CTV Building Geotechnical Advice

This report presents the review of geotechnical conditions at the site of the CTV building, 249 Madras Street, Christchurch, together with the results of an assessment of the dynamic response parameters for the foundations of the building.

CTV Building Geotechnical Advice - Addendum

Figure 2: Locations of Strong Motion Recording Stations

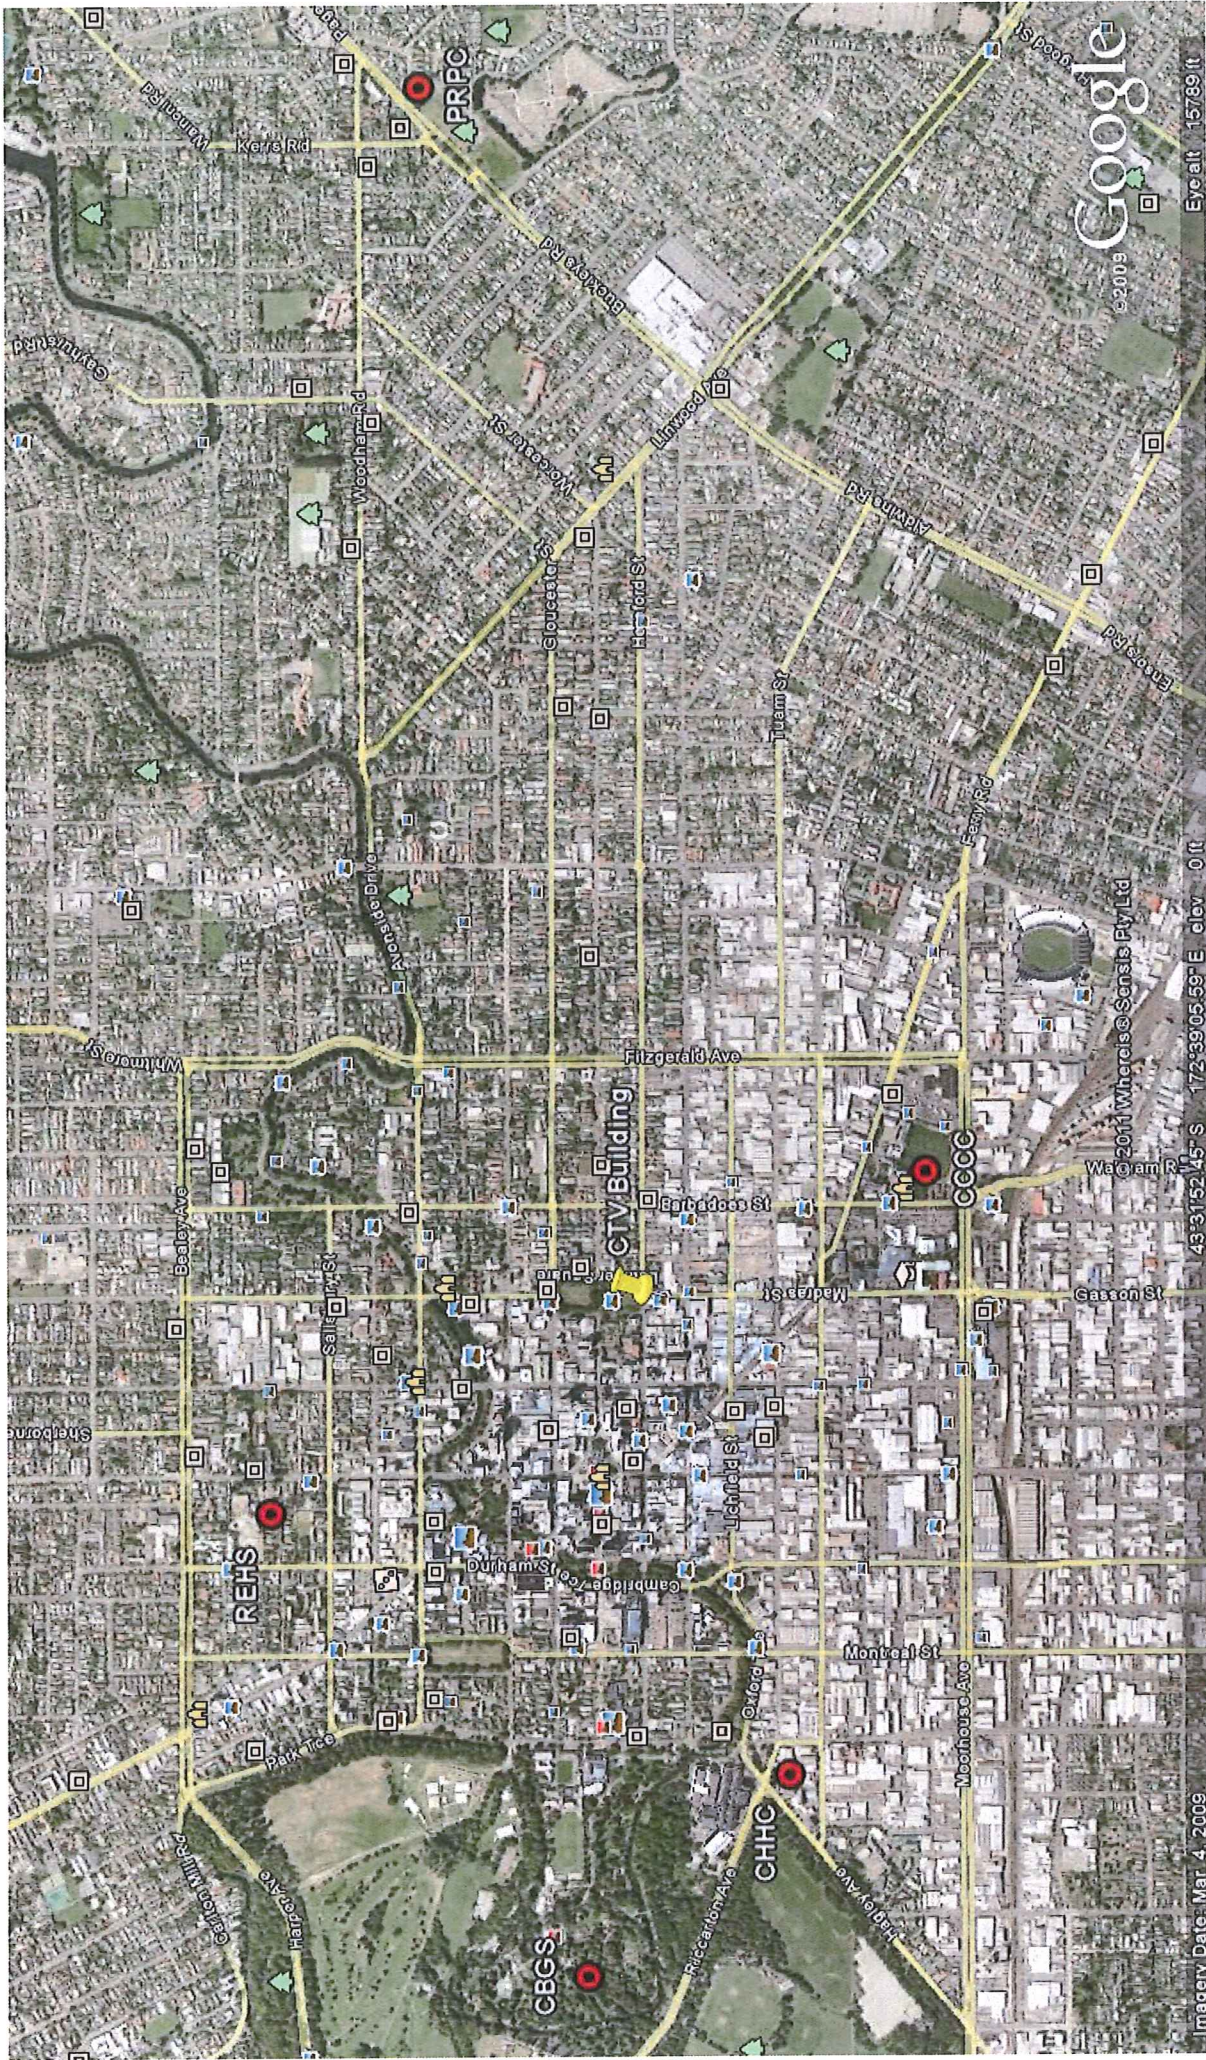
The five stations of interest are shown on Figure 2 and are listed below:

The last two of these (REHS and PRPC) show significantly higher amplification than the others, both with respect to Peak Ground Accelerations (PGA) and spectral accelerations.

The response characteristics are generally governed by the soil profile to rock which would be about 300 m depth, and so thin layers near surface are not likely to make much difference. The exception, of course, could be the presence of deep liquefiable soils and/or the presence of peat. For this reason we consider the REHS and PPC records should be disregarded and the CTV site response should be assumed as similar to the average of the other three stations.

Westpac Building

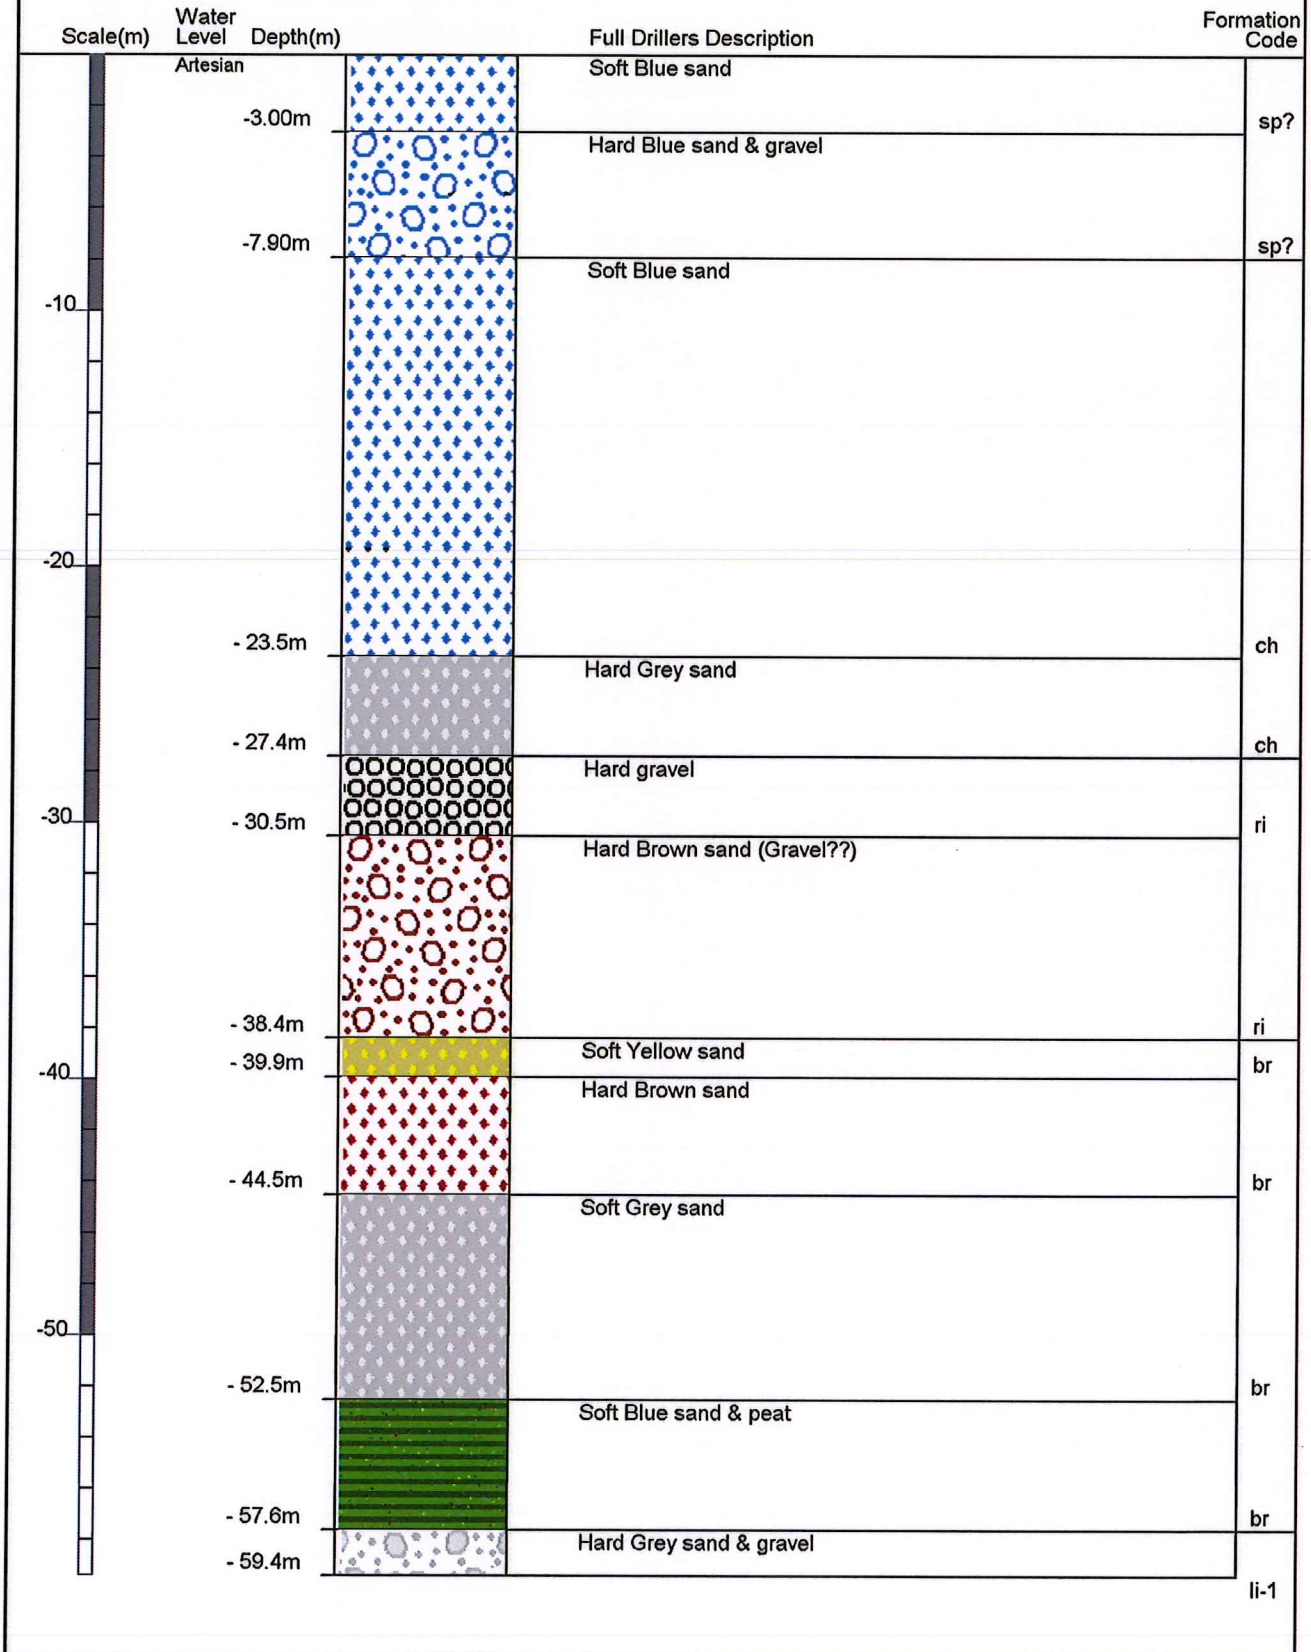
- i. The locations for the site investigation points surrounding the Westpac Building are shown on Figure A1 attached. (Note: Station 503E is marked on this plan but not in exact location due to co-ordinate discrepancy.)

- iv. The GeoNet DELTA site gives descriptive information, including assumed layer thicknesses, which agree with the above information.
- v. Conclusion: The site conditions here are very similar to the conditions for the major portion of the CTV Building site, over which the gravel layer is present.
